CHANGE ORDER APPROVAL FORM

PROJECT: William Burgess Extension

CHANGE ORDER NUMBER: 004

CHANGE ORDER No. 04 - ESTIMATED COSTS - REV08 Embankment Quantity Added

CROSS SECTIONS		SHEET NO.
WILLIAM BURGESS BLVD. EXTENSION NASSAU COUNTY, FLORIDA		151

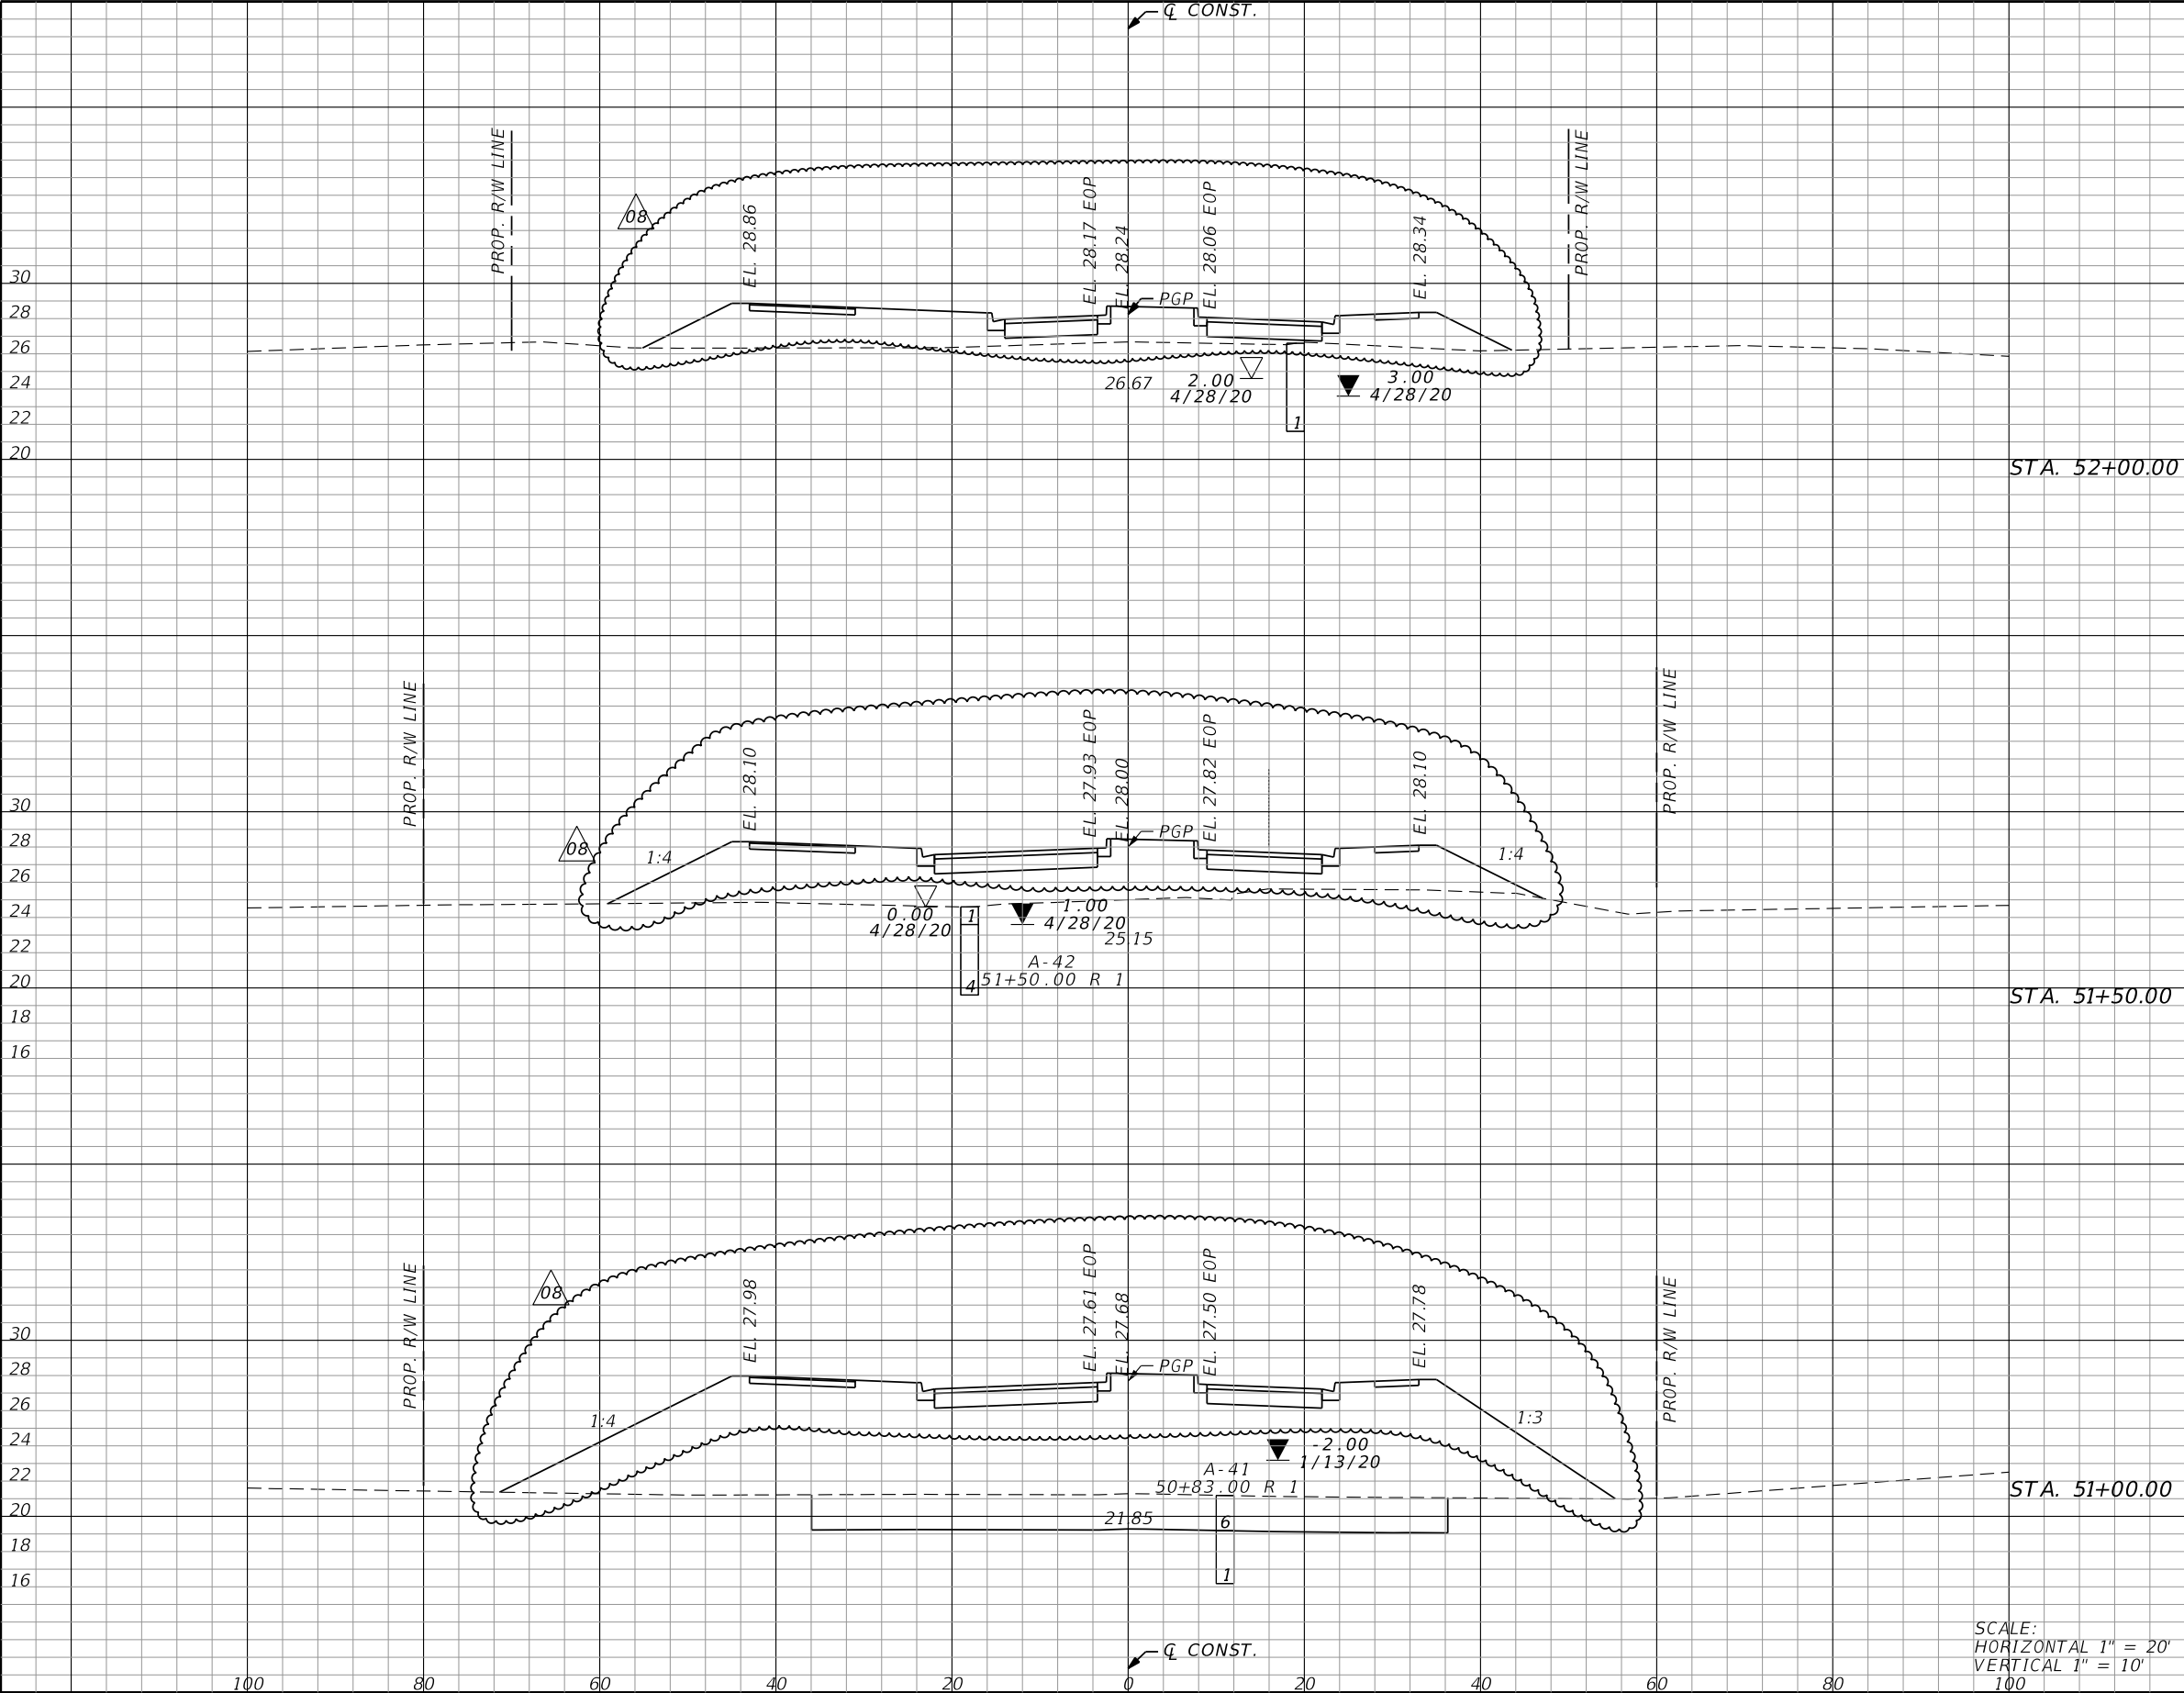
REVISIONS			
REV	DATE	BY	DESCRIPTION
08	5/6/25	RFH	REVISED PROFILE ELEVATIONS

CROSS SECTIONS

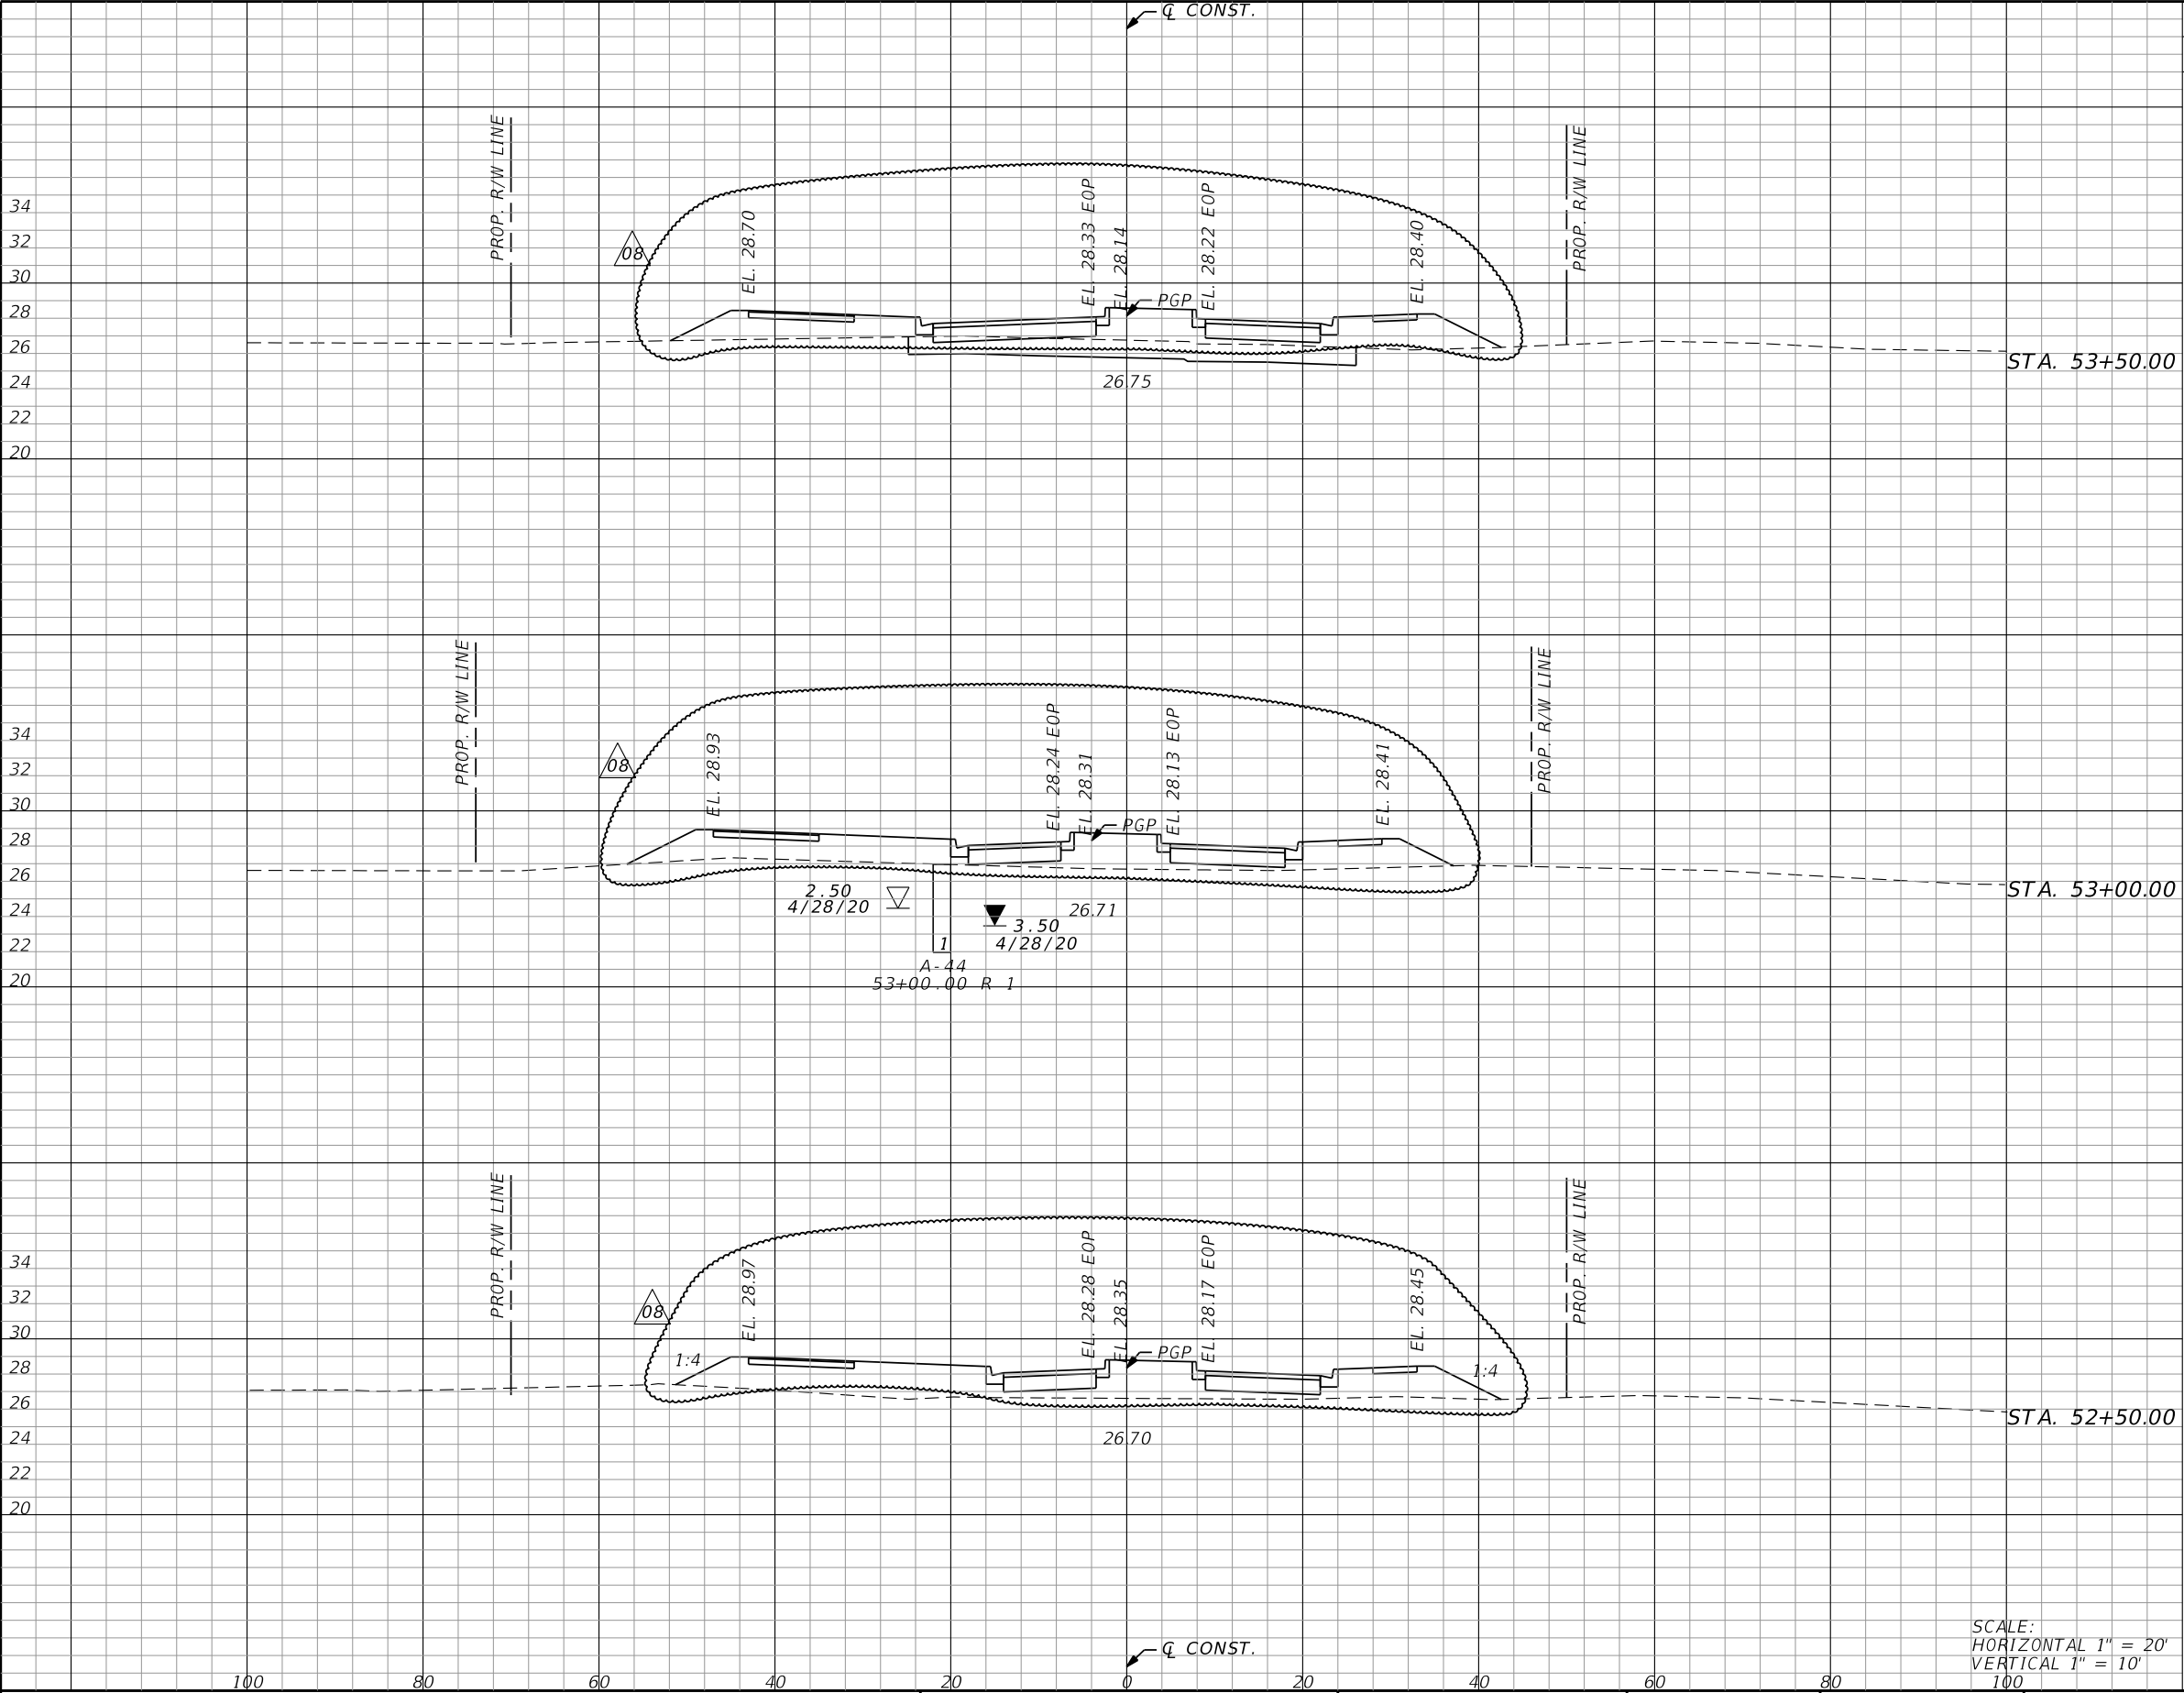
REVISIONS			
REV	DATE	BY	DESCRIPTION
08	5/6/25	RFH	REVISED PROFILE ELEVATIONS

CROSS SECTIONS

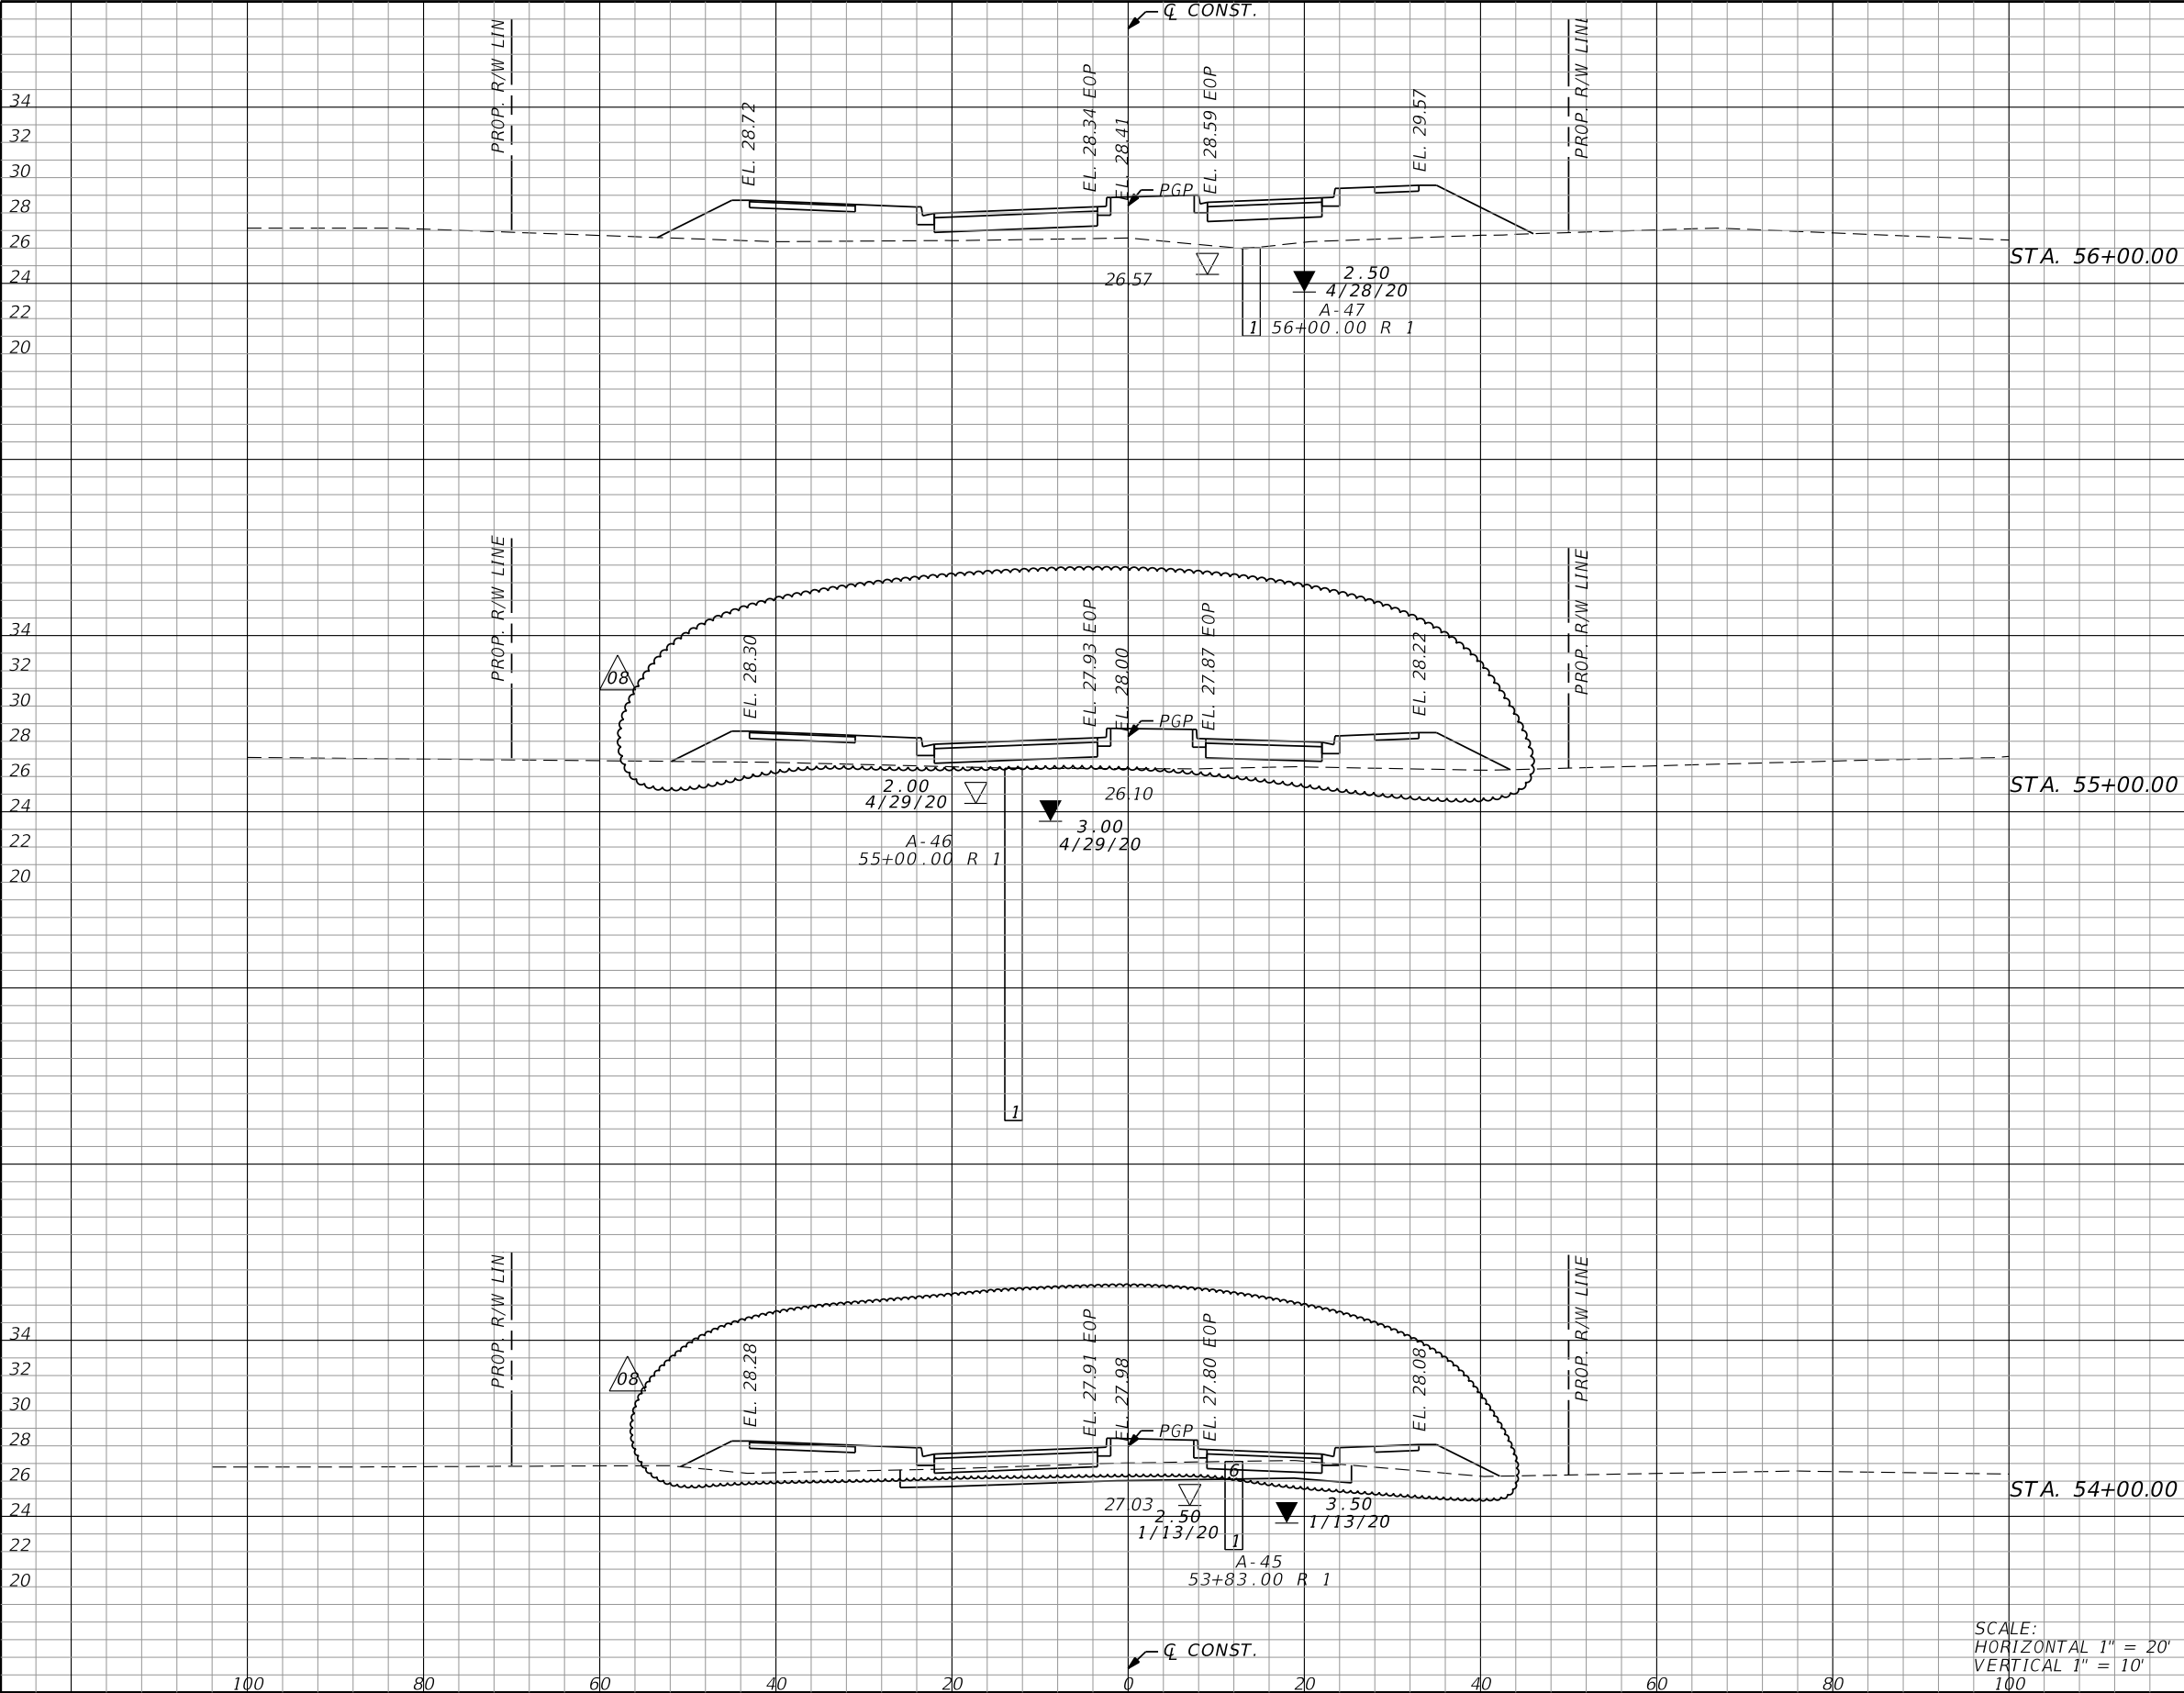
Subsoil Exc.		Regular Exc.		Embankment	
A	V	A	V	A	V
0.0		0.0		161.4	
0.0		0.0		487.0	
0.0		0.0		101.5	
94.6		1.3		384.5	
51.1		0.7		106.1	
				487.5	
				332.3	
				16,296.6 CY	
				11,022.2 CY	
				5,274.4 CY

REVISIONS			
REV	DATE	BY	DESCRIPTION
08	5/6/25	RFH	REVISED PROFILE ELEVATIONS
